CREEKSIDE SOUTH AT LORSON RANCH FILING NO. 1

FINAL PLAT
CREEKSIDE SOUTH AT LORSON RANCH FILING NO. 1
JOB NO. 70-089
DATE PREPARED: 05/11/2020
DATE REVISED: 11/17/2020

Plat V_4 redline planning.pdf Markup Summary 12-11-2020

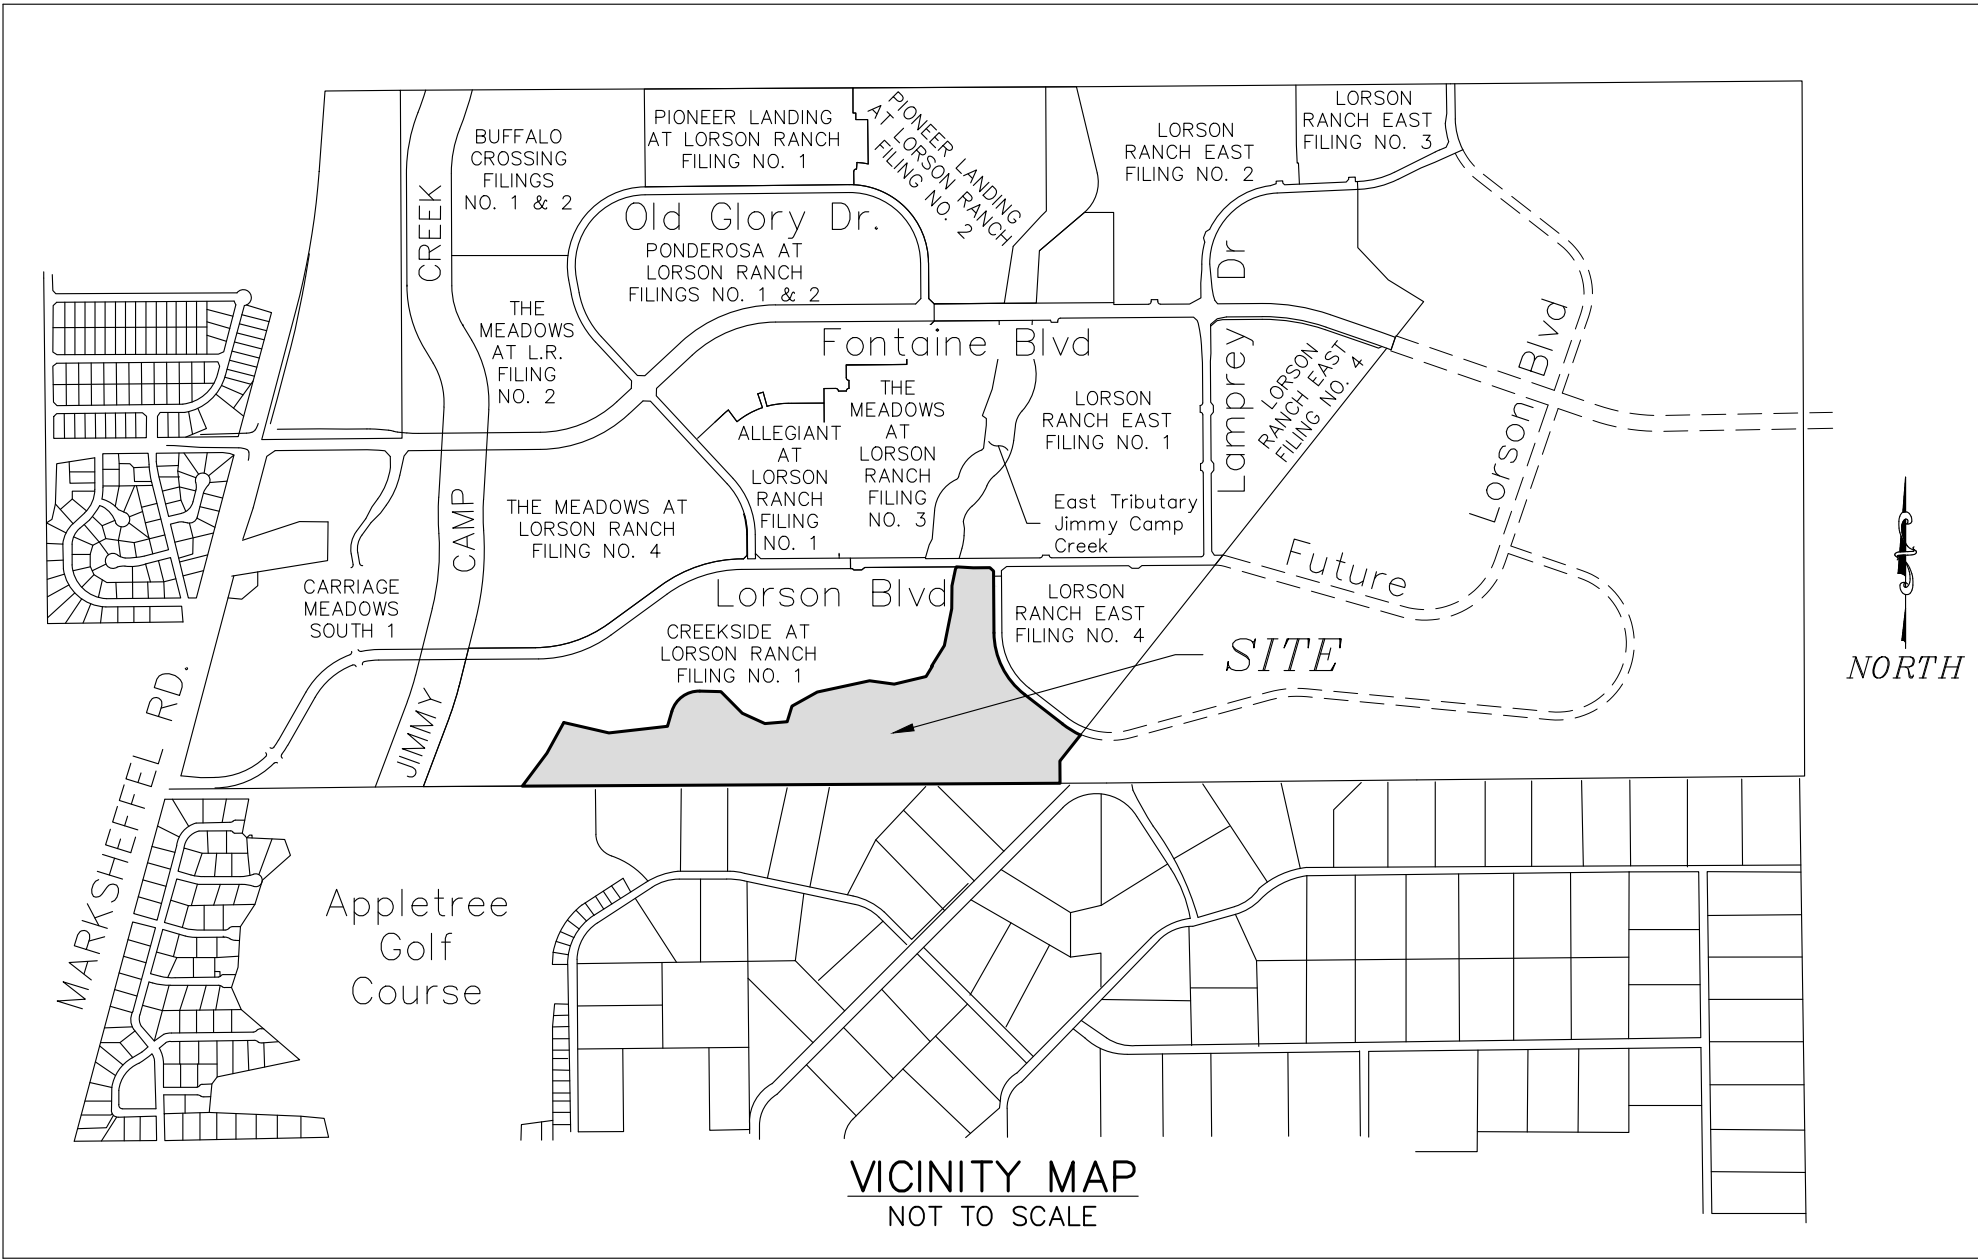
100'- structure setback (no build area) is required

delete easement note
Move to ADDITIONAL NOTES; also add 2.5 acre lot size minimum is required on these lots and no further subdivision of those lots is permitted

? Is this correct? pr-credits?

SHEET 4 OF 7

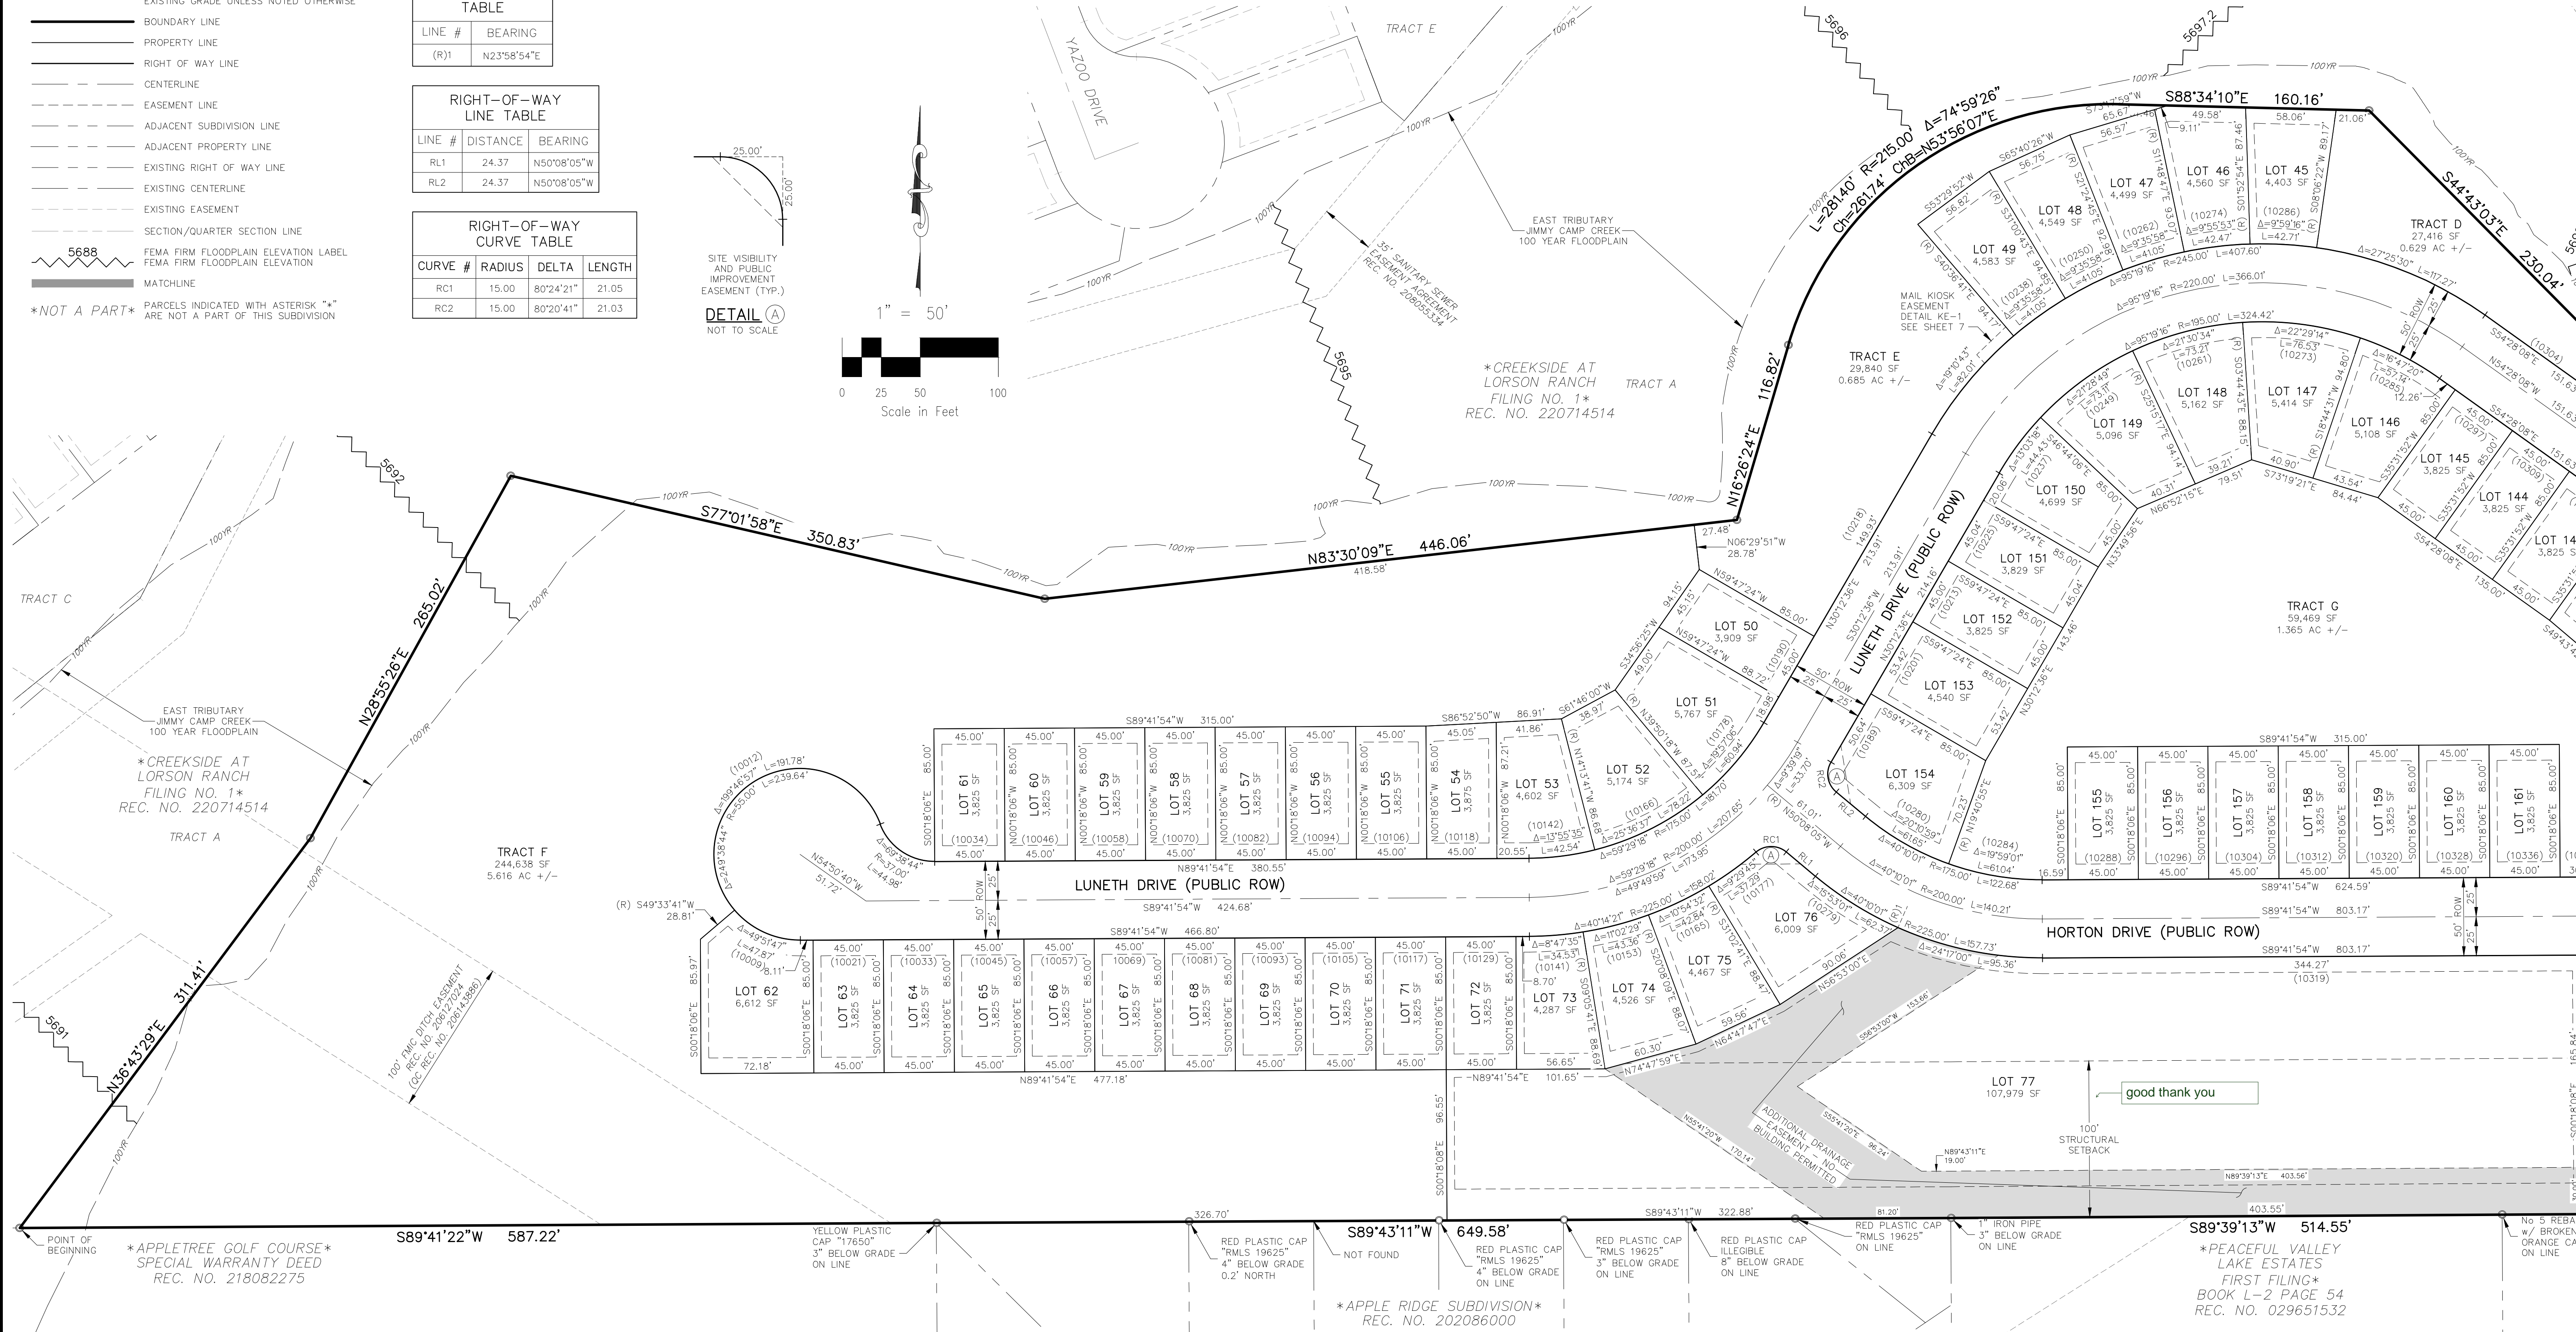
good thank you
